Comment Letter O3

**Re: Jacumba Solar Energy Project Draft Environmental Impact Report
 PDS2014-MUP-14-041, PDS2014-ER-14-22-001 (SCH No. 2014091034)**

Response to Comment Letter O3

**Stephan C. Volker on behalf of
 Backcountry Against Dumps and Donna Tisdale
 June 1, 2015**

Graph 1 - Common Spectral Surfaces

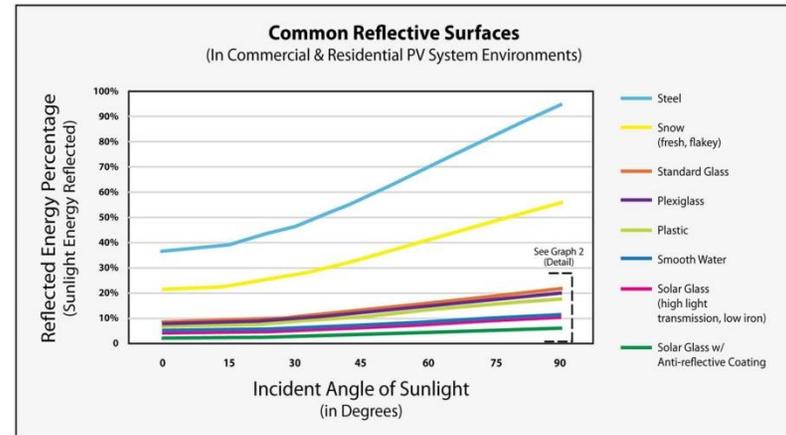
The DEIR downplays the significant threat that the Project poses to avian species from the pseudo-lake effect. It fails to acknowledge that Jacumba Lake is a nearby water body which attracts important and special status species such as the tri-colored blackbird. It trivializes the Project’s location along the Pacific Flyway in disclaiming any potentially significant impacts. DEIR 2.2-4-7 (“the locale is not considered to be a major contributor to the Pacific Flyway,” and is not located near water bodies that would attract water-birds). But the Project’s dangers to migrating waterfowl that would collide with the Project’s planned 81,108 PV modules (as mounted on 2,253 fixed tilt racks) are not alleviated by either its location or design. *Id.* The DEIR fails to analyze ways to modify the Project’s location and design to reduce its impacts on avians.

Further, while the DEIR suggests that the Project “may not appear like water from above,” it conducts no analysis to support this claim. Contrary to the DEIR’s self-serving assumption, when viewed from above, the Project is likely to appear like shimmering wetlands to birds, potentially luring them to try to land on the trackers. This is true not only during the day, but also on clear nights, when the panels will continue to reflect the sky, moon, and stars. Indeed, the PV Desert Sunlight facility in Riverside County has attracted night-migrating birds and water birds, including the endangered Yuma clapper rail, even though the nearest water body is over 25 miles away, in many instances with deadly results.¹ The DEIR fails to distinguish this Project from Desert Sunlight and its tragic history of avian mortality. Additionally, the DEIR’s proposed mitigation measure – monitoring and recording any impact *after* it occurs – does nothing to *prevent* such impacts. Therefore it cannot reduce the impact to a less-than-significant level without additional preventative measures as well as restorative actions. DEIR 2-2.100.

<p>The Proposed Project instead would consist of typical PV panels, unlike other solar projects that have reported avian deaths, the Proposed Project will not have evaporation ponds, mirrors, or heliostats panels.</p> <p>Of these solar facilities, Desert Sunlight is the only photovoltaic facility with similar technology to the Project and is further cited by the commenter. The commenter references the Desert Sunlight facility in Riverside as evidence that PV solar facilities are attracting and killing migratory and water birds even when not located near a water body. The experts who prepared the DEIR reviewed the Desert Sunlight facility and its annual report on avian and bat mortality (Appendix B, Avian and Bat Mortality Solar Farm, Ironwood Consulting, Inc. n.d.), and still concluded that potential impacts to avian species were too speculative to evaluate or draw a conclusion that there was a significant environmental impact to avian species. Specifically, the Desert Sunlight project differs from this Proposed Project in that it is set in a wide open valley as opposed to the Proposed Project, which is backed up between a mountain and a large existing fence (International Border Fence). The Proposed Project would have solar units that are uniformly dark in color, coated to be non-reflective, and designed to be highly absorptive of all light that strikes their glass surfaces so they would not appear like water from above, as water displays different</p>

properties by both reflecting and absorbing light waves. (See DEIR, p. 2.2-47.) Furthermore, the Desert Sunlight panels are close to one another, but the Proposed Project's panels are approximately 12.5 feet apart. This breaks up sky reflection from a single continuous surface to individual separate units and reduces the image of a continuous body of water. Included below is a chart demonstrating the low reflectivity of PV panels compared to other surfaces, including water (Common Reflective Surfaces).

The Desert Sunlight project is also situated between the Salton Sea and the Colorado River, where most of the birds in the Pacific Flyway migrate. In contrast, the Proposed Project is substantially smaller in size and located in a portion of the Pacific Flyway with low incidences of avian flight paths because it is located east of the main coastal migration route and west of the primary route between the Gulf of California and the Salton Sea. The Proposed Project site's location in the mountains away from the coast or Imperial Valley and not being situated between large bodies of water also reduces its potential to attract migratory bird species. (DEIR, p. 2.2-66.)

All of these distinguishing characteristics references above led the experts who prepared the DEIR to conclude that it is too speculative to conclude the Proposed Project would have a significant impact on avian mortality generally or to be confused for a body of water.

Nevertheless, in an abundance of caution, and despite the lack of any significant environmental impact arising from pseudo lake effect, the Project will implement recommendations by the Avian Power Line Interaction Committee (APLIC) which generally will reduce the likelihood of electrocutions and avian collisions with Project structures (See M-BI-13). Recommendations provided by APLIC focus on preventing electrocution through design features on new structures. These design features include a minimum separation of 60 inches
